CERTIFICATE OF APPROPRIATENESS

Property: 1233 Rutland Street, lot 4, block 183, Houston Heights Subdivision. The property consists of a one-story single-family residence situated 6,600 square foot (50' x 132') interior lot.

Proposal: Alteration – Window, Revision to existing COA

Recommendation: **Approval with Conditions: revise window dimensions to match size of 1/1 kitchen window in either wood or vinyl**

SOUTH SIDE ELEVATION

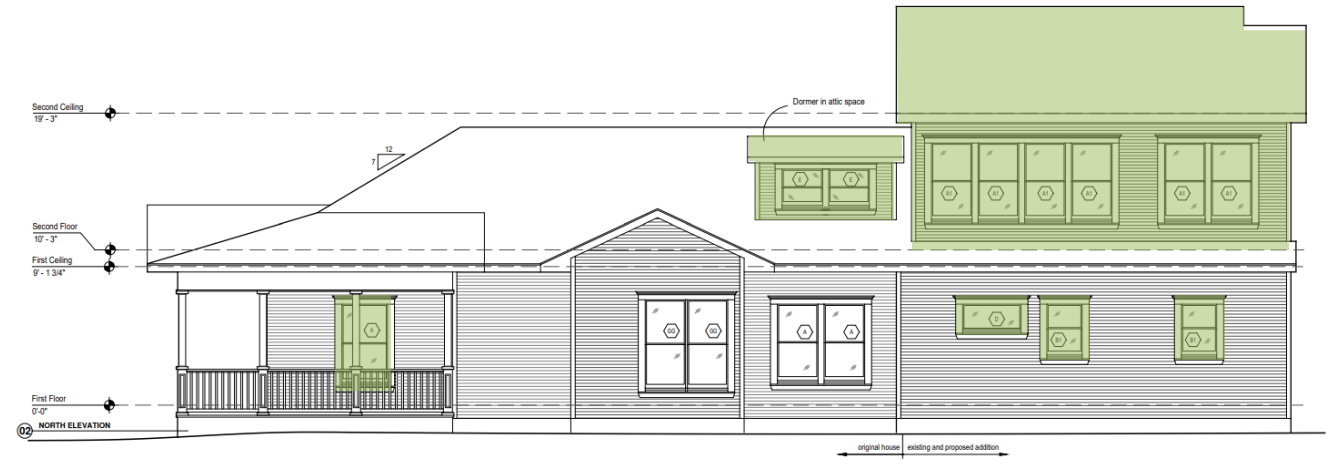
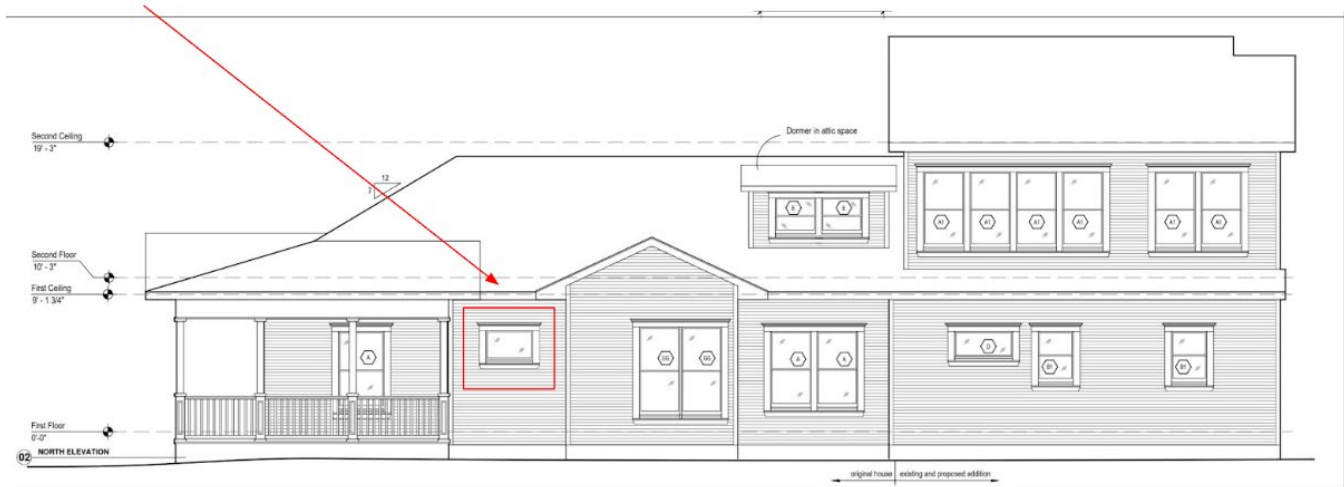
<i>Type and material of the proposed awning window are not compatible with character of the property.</i>
<i>Revised 1/1 window proposal is compatible with kitchen windows.</i> | |

PREVIOUSLY PROPOSED – 11/17/21 Approved w/ Conditions by HAHC

CURRENT PROPOSAL

Proposed Downstairs Floor Plan with New Window

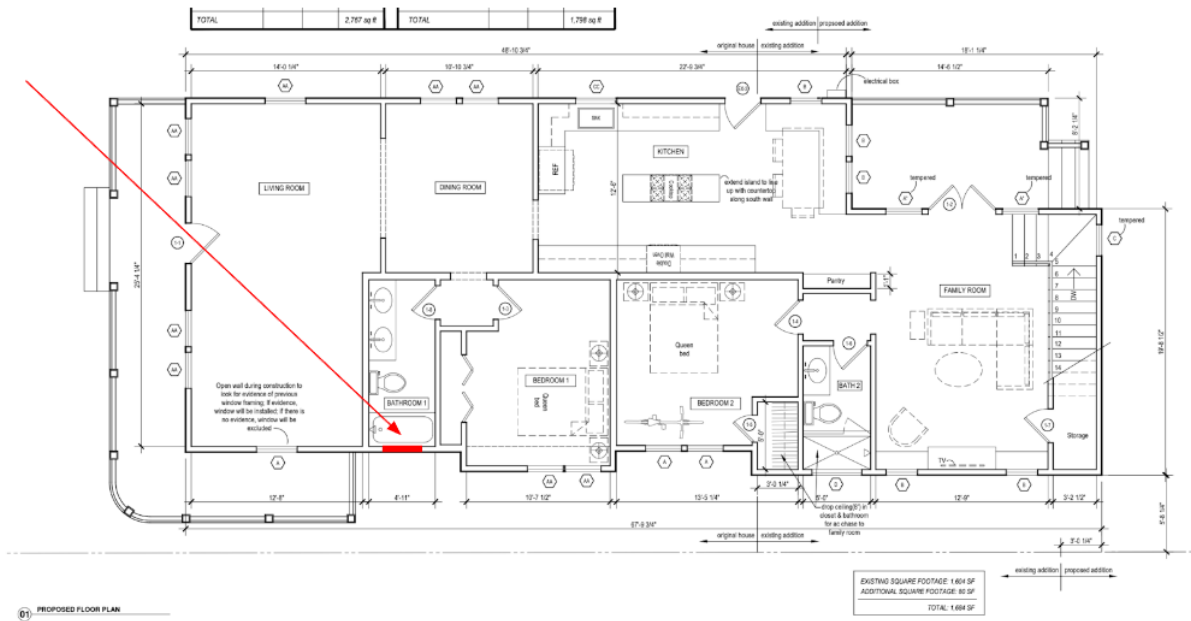
Add a window to the first floor bathroom. During construction, we discovered a window frame under the sheet rock in the bathroom. Knowing that there used to be a window there, we are requesting permission to bring the room closer to its original state by adding a new window. We propose adding a window that is the same width as the other windows throughout the house (32"). Here is a slide deck showing the location of the bathroom, the wall in question, and the proposed window:
